Historic District Commission

Wednesday, September 18, 2019

COA-2019-07 – 89 Main Street – Colonial Theatre Renovations and Addition

Re: HDC COA-2019-07

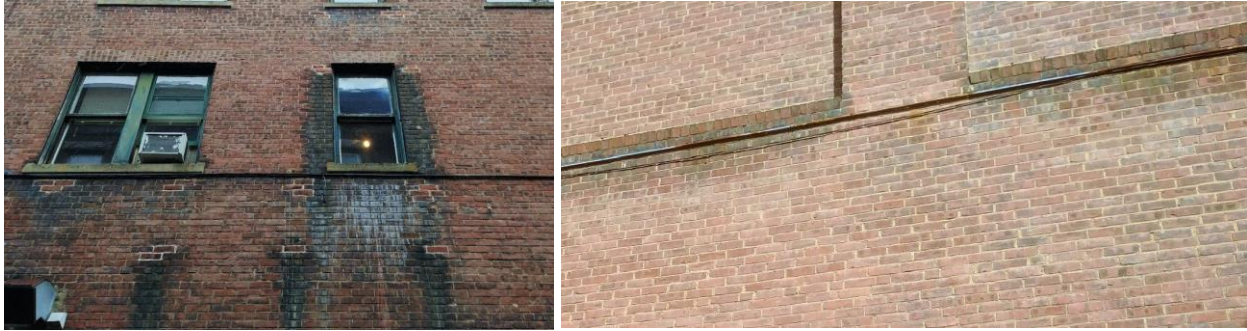
The applicant proposes to clean existing brick masonry where water damage has occurred, primarily along the south façade of the building where an exterior fire escape was located (removed circa 1995) and along and below recessed brick panels. No masonry cleaning is proposed on the front, east façade of the building facing Main Street.

The project narrative states that the masonry will be cleaned using “a low pressure spray, roller, or soft fiber brush.” The proposed cleaner is Diedrich 101 Masonry Restorer. The cut sheet for this product states that this cleaner uses a combination of acids (hydrofluoric acid and hydrochloric acid) and biodegradable detergent to clean masonry surfaces, and has a pH of 5.3 when diluted 1:10 with water. Staff recommend that a test patch be inspected prior to brick cleaning to ensure no adverse reactions to the proposed cleaner and cleaning method. In addition, the Board may wish to clarify with the applicant what is meant by “low pressure” in terms of PSI.

10. The active ingredients of Diedrich 101 Masonry Restorer are listed in the attached Material Safety Data Sheet. The dilution level we intend to use can only be determined by a test patch prior to full scale cleaning operations. The test patch is necessary to determine compatibility, dilution rates, and required end results.

Above: line sketch depicting the scale and massing of the proposed addition, as viewed from Gilbo Avenue.

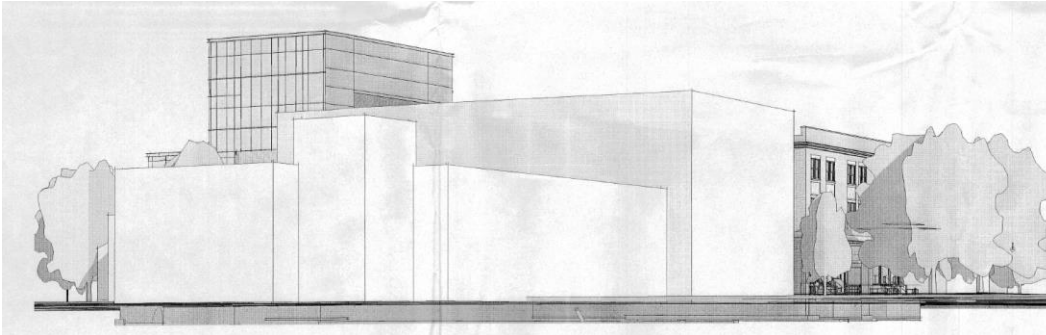
The applicant has requested a waiver from this standard to permit an addition that would increase the building’s height above adjacent or nearby rooflines. The addition would not alter the front of the building. The waiver request is included as an attachment to this staff report. The proposed addition, while taller than the surrounding buildings, is within the allowable height in the district by Special Exception. The height increase is specific to the rear portion of the building, which is set back by about 150 feet from Main Street. The applicant provided line sketches to show the scale and massing of the proposed addition in relation to nearby buildings from different vantage points (see illustrations on following page).

Figure 12 – West Elevation of Addition to Stagehouse

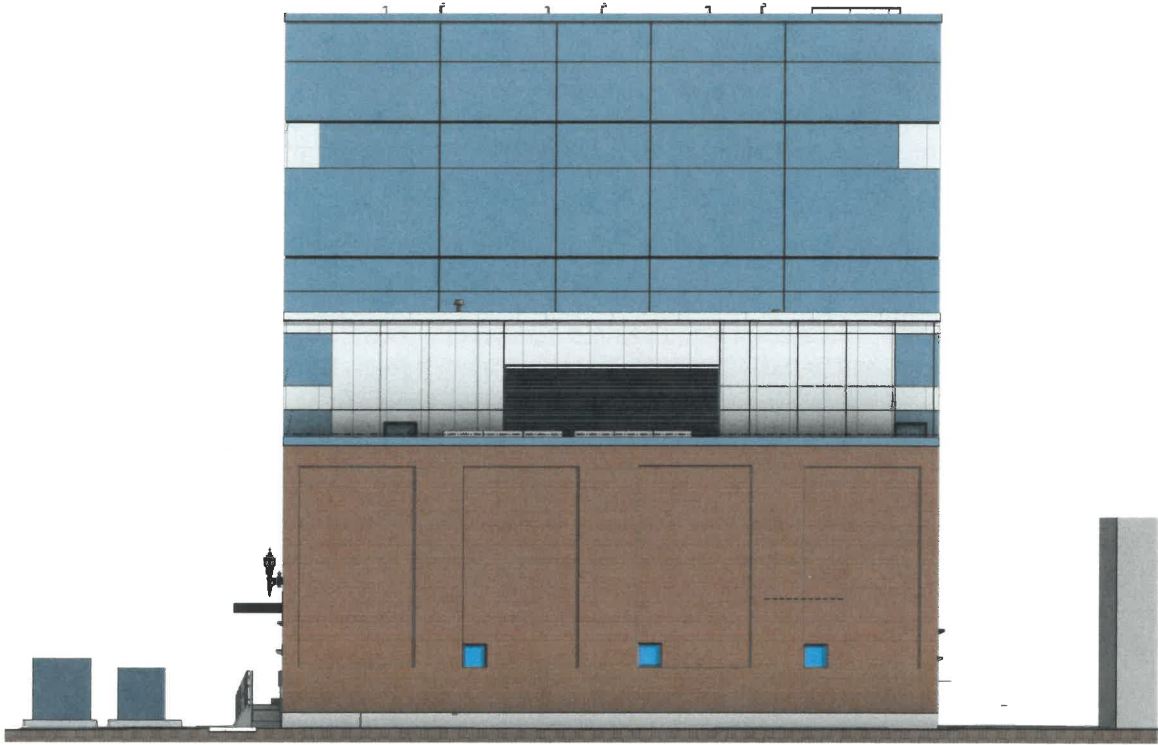
The applicant notes that the architectural design of the proposed addition is intended to visually decrease the large scale and massing of the structure through articulation with horizontal and vertical lines, the use of different exterior materials with differing textures, and the use of a mixture of colors. The applicant notes in a memo to staff dated 9/5/19 that the varying colors of the insulated metal panel system are meant to evoke the polychromatic nature of the brick on the primary façade of the existing building. The lower, rear portion of the proposed addition would be clad in a brick veneer product and would include recessed brick panels to complement the brick detail on the north and south façades of the existing structure. This section of the addition would be separated from the historic, brick-clad portion of the building with a more modern, insulated metal panel system, as shown in the following architectural elevations for the north, south, and west facades of the proposed addition.

The proposed addition would be about 15 feet taller than the existing stage house, or about 75 feet above grade. This is about 31 feet taller than the main body of the building. The applicant received a Special Exception from Section 102-791 (“Basic Zone Dimensional Requirements) of the Zoning Ordinance to increase the maximum building height from 55 feet to 75 feet. The applicant notes in the project narrative that this height is required in order to accommodate modern theatre productions.

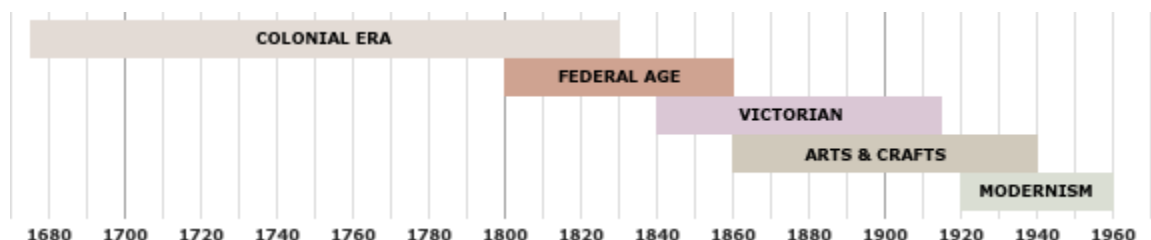
6. No new building penetrations / vent openings are proposed on the existing building.
7. A solar PV array was contemplated for the roof of the existing building. Based on the information currently available, roof panels for this system could be seen from the private parking lot of abutters to the south west, as well as from Emerald Street. Additional investigation and research is needed before the system design can be finalized, and specific questions answered. The applicant is withdrawing this aspect of the project from the current COA request. If the PV system is pursued further, the applicant will prepare a new and separate COA application at that time.

8. Repairs and maintenance to the existing building exterior include brick cleaning and may include repointing if unsound mortar is encountered during the cleaning process. Attached are photos showing typical areas on the existing building where brick cleaning is proposed. None of the polychromatic brick on the primary / east façade needs to be cleaned or repointed.
